**SAN ANTONIO WATER SYSTEM  
REGIONAL CARRIZO PROGRAM  
COMMUNICATION TOWERS PROJECT  
SAWS Job No. 12-8613  
Solicitation No. B-12-055-RA**

**ADDENDUM NO. 1**

**September 5, 2012**

**ELEVATION**  
N.T.S.

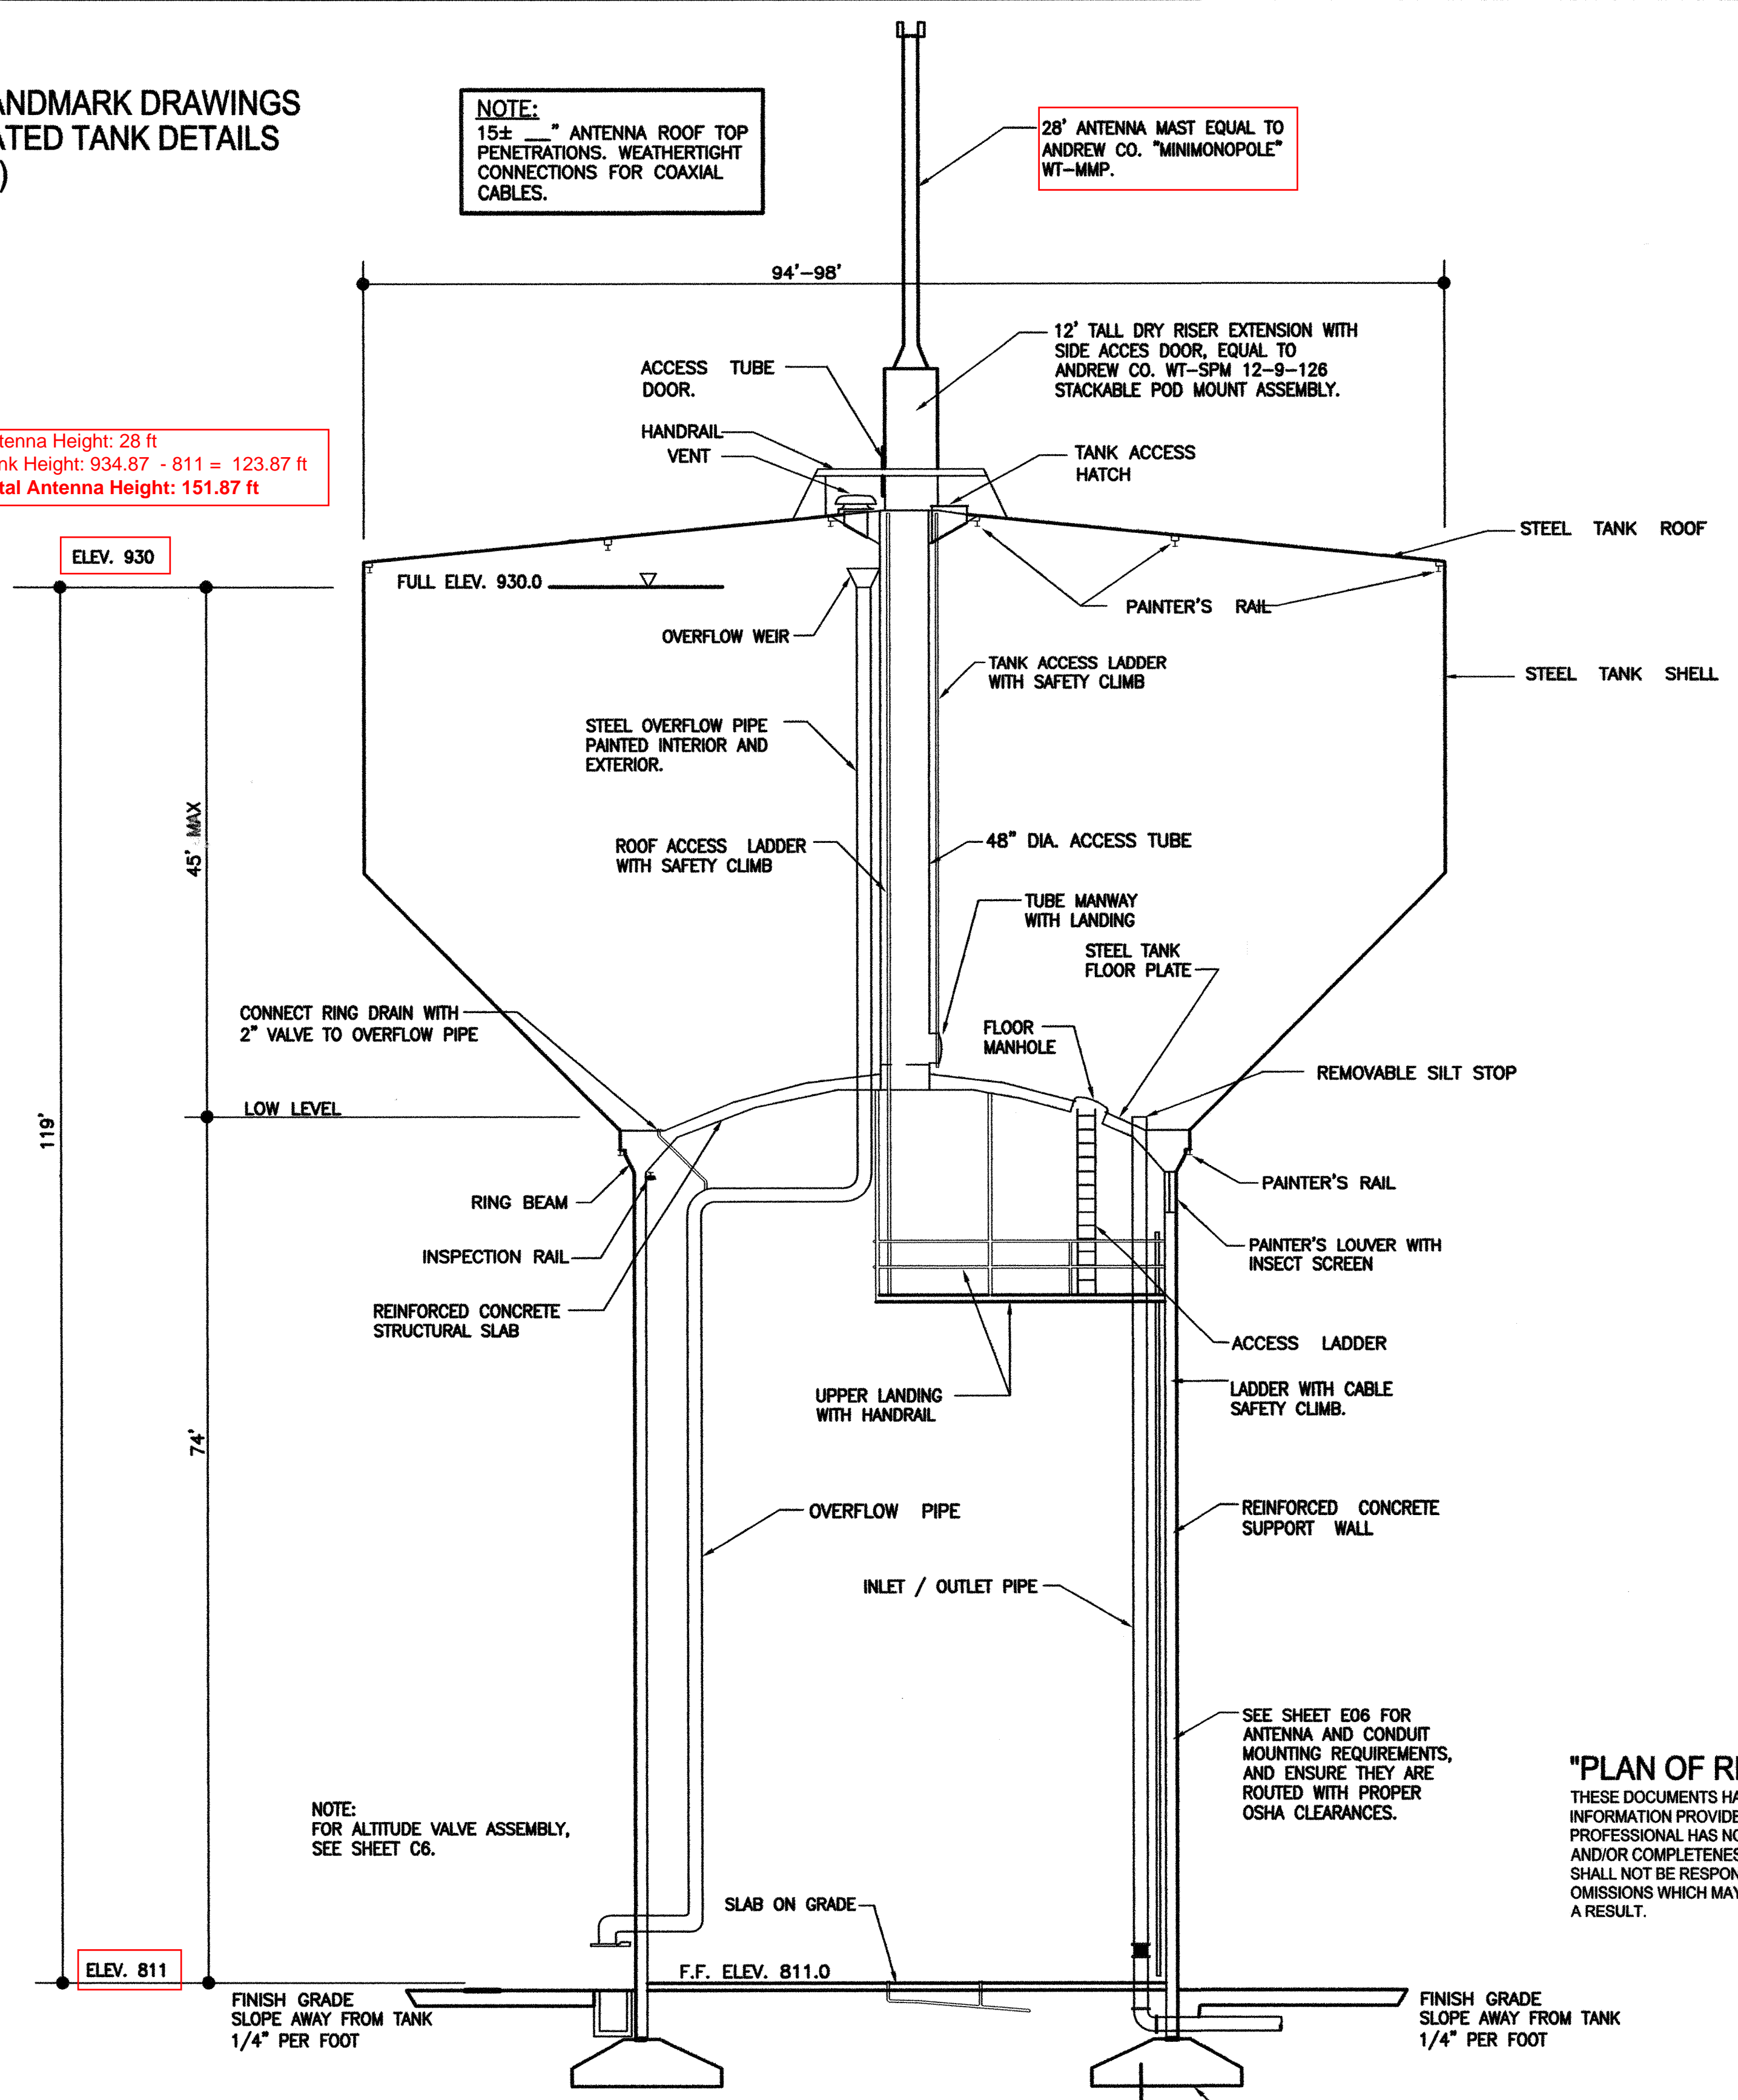
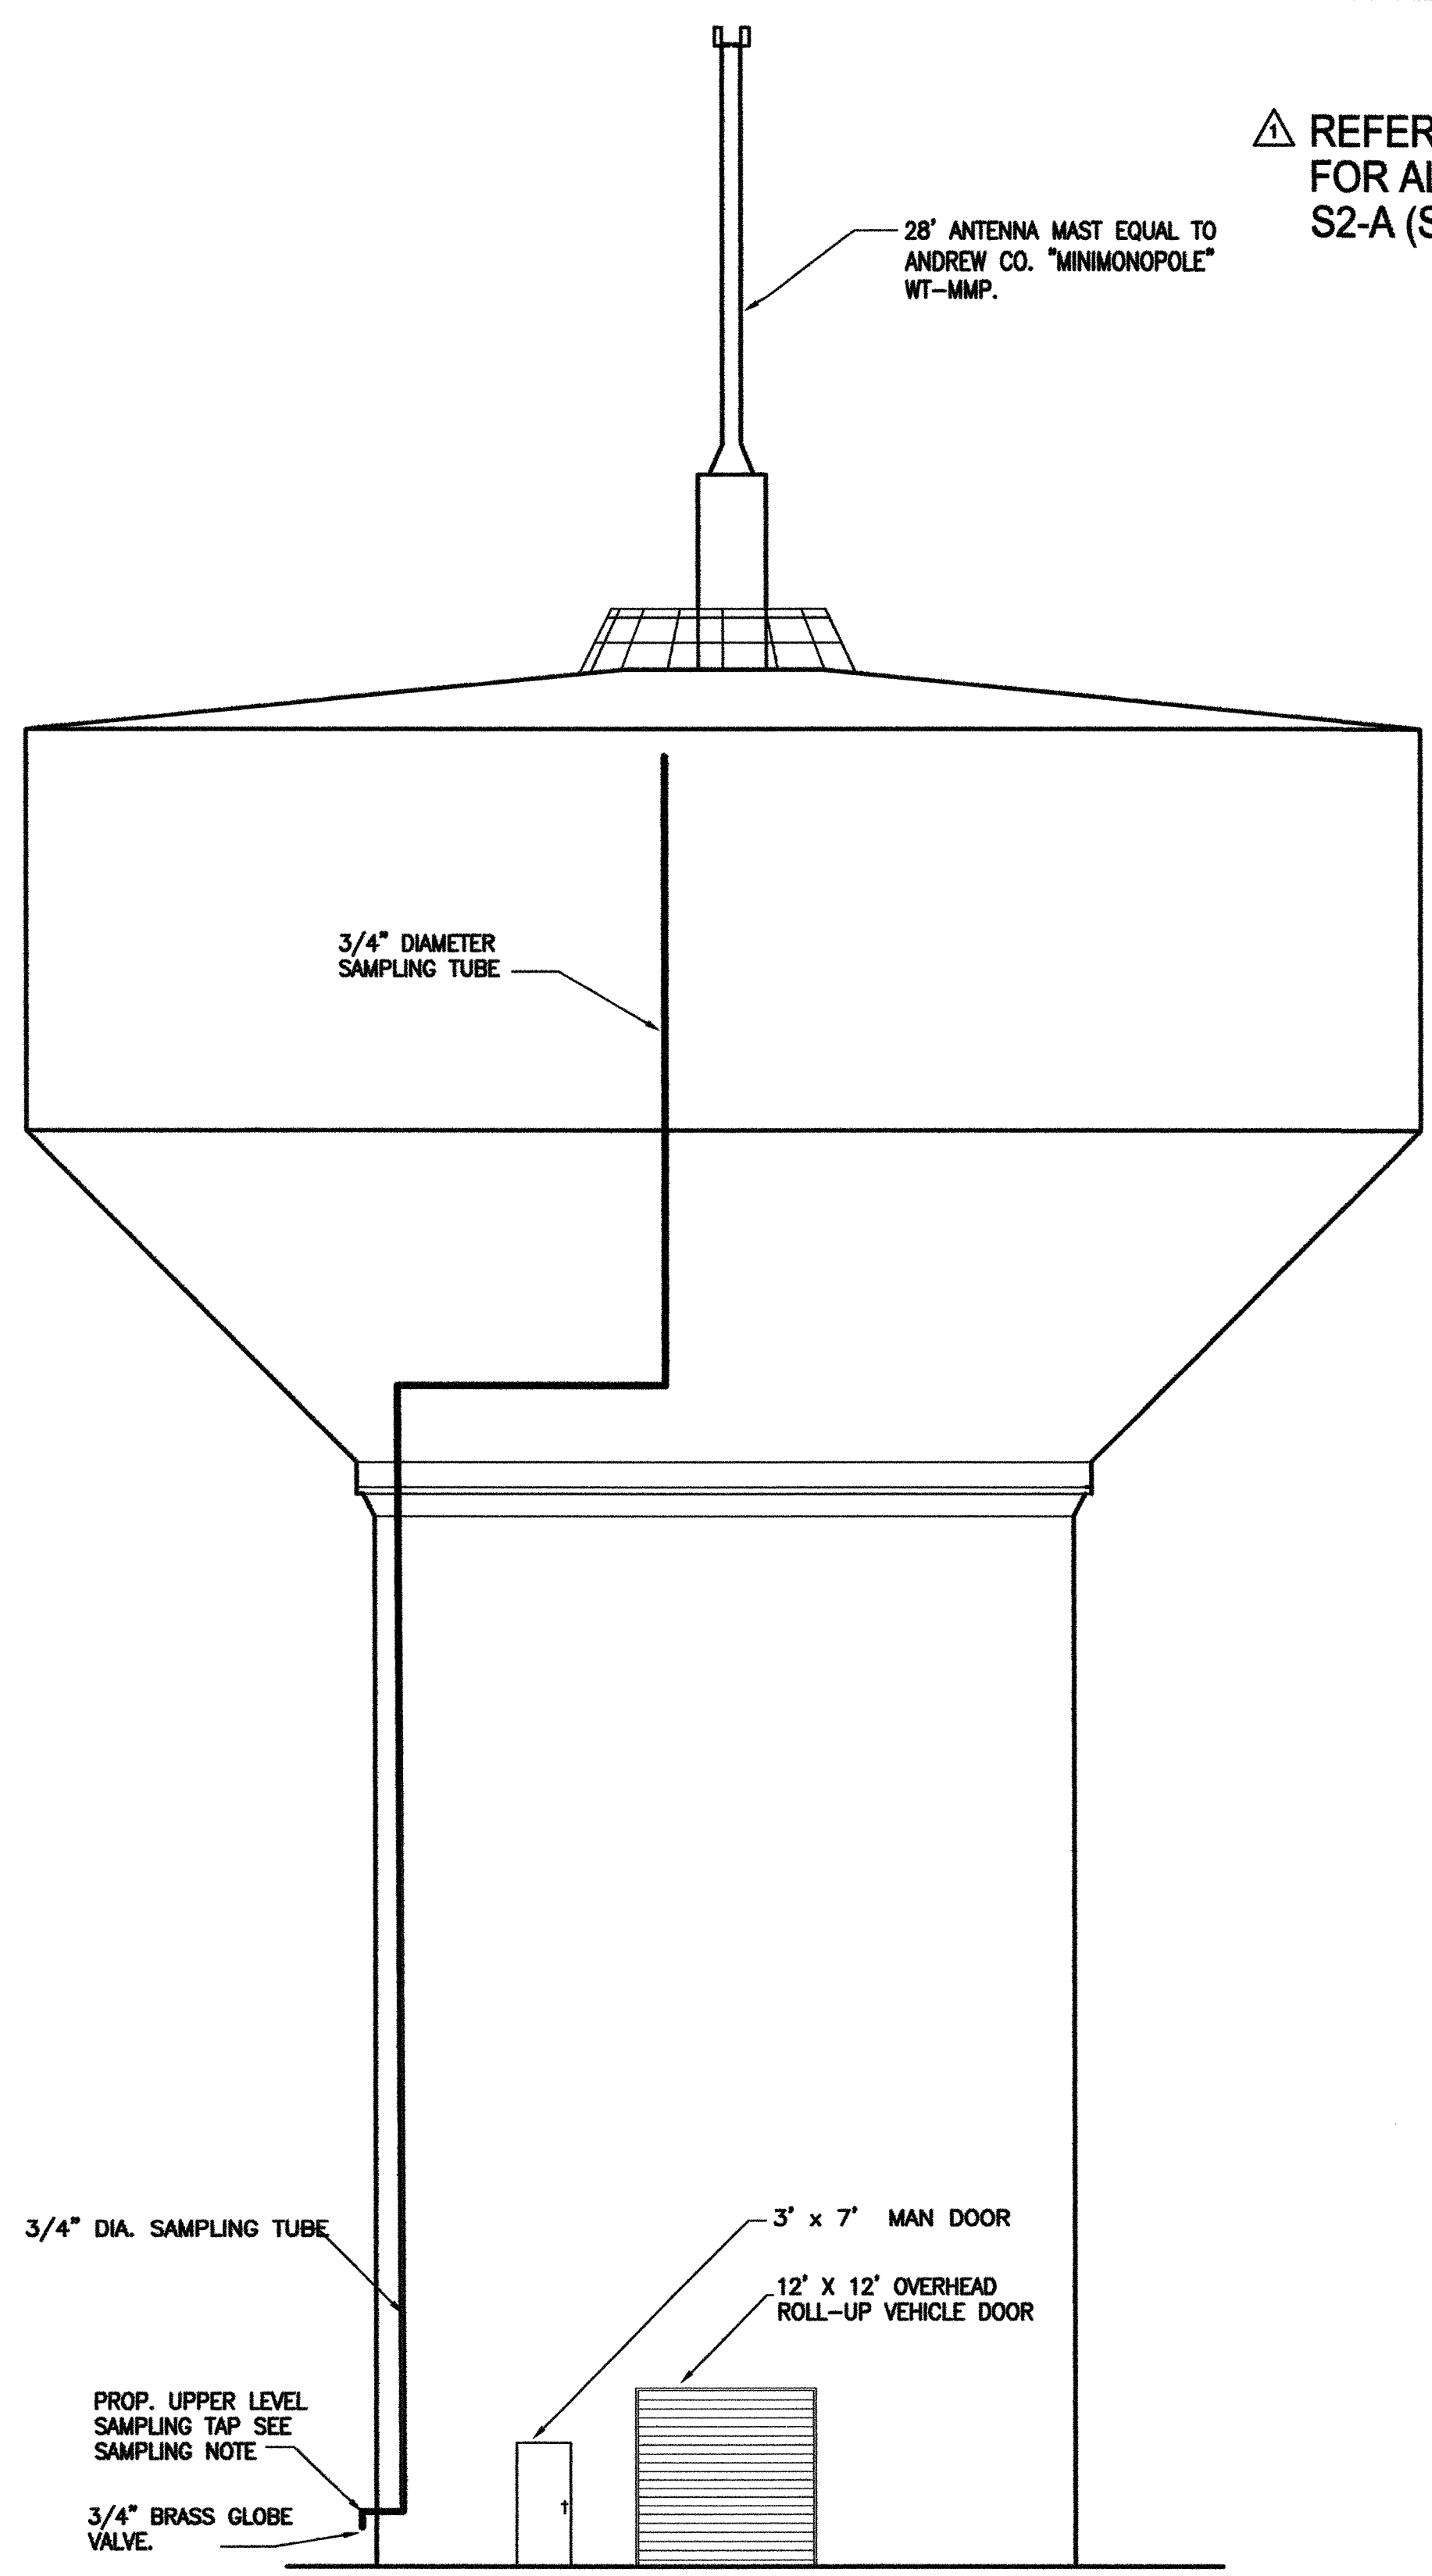
3. SAWS Hildebrand Elevated Storage Tank – mounting hardware to be provided by Contractor. See drawings of monopole attached.”
4. SECTION 13000, add paragraph 2.03.M as follows:
